**1985 Chevrolet Corvette V8-350 5.7L**

**M/T - Loss of Overdrive Operation**

Subject: LOSS OF OVERDRIVE - 4-SPEED MANUAL TRANSMISSION

Model and Year: 1984-85 CORVETTE

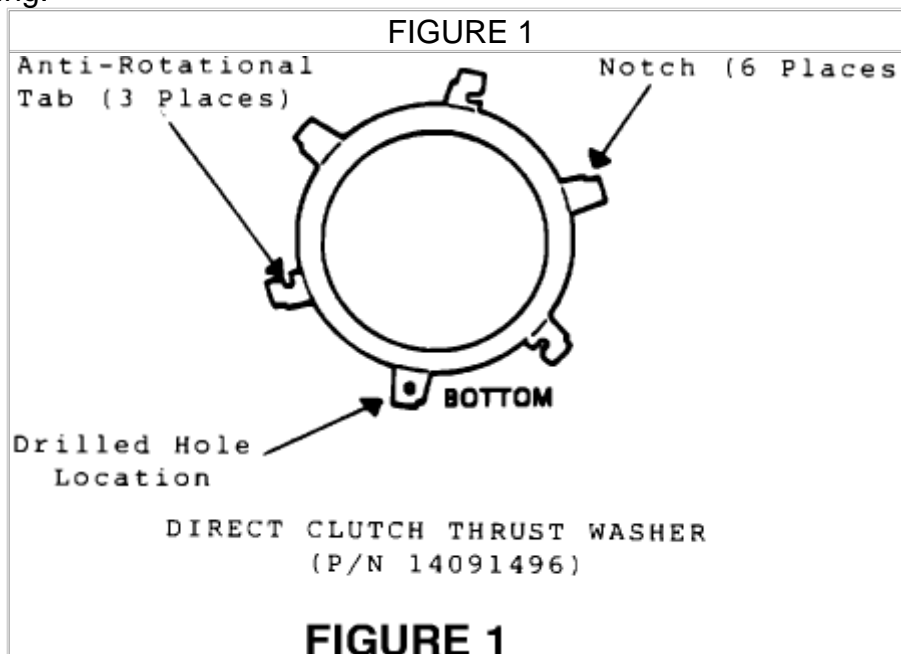
This condition may be caused by a hang-up of the direct clutch thrust washer if the washer groove in the overdrive unit's aluminum [case](#), the washer may then hang up in this groove | applying.

On transmissions beginning with serial number D4L 10837CD, a new direct clutch thrust washer (P/N 14091496) incorporates notches in all the tangs as well as anti-rotational tab: Figure 1) which prevent the washer from contacting the [case](#) wall.

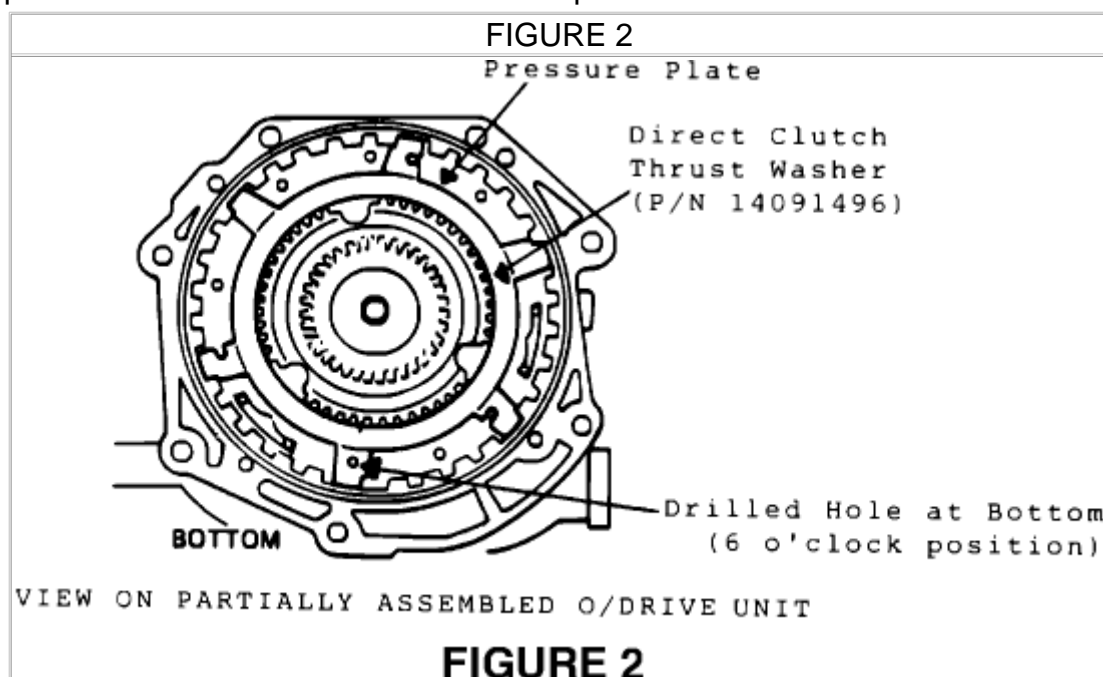
3. Replace the direct clutch thrust washer with the new, P/N 14091496, washer. Install the [pressure plate](#) and ensuring that the anti-rotational tabs are located in the pockets in the case that the finger on the washer that has the drilled hole is located to the bottom of the [case](#). See Figure 2.
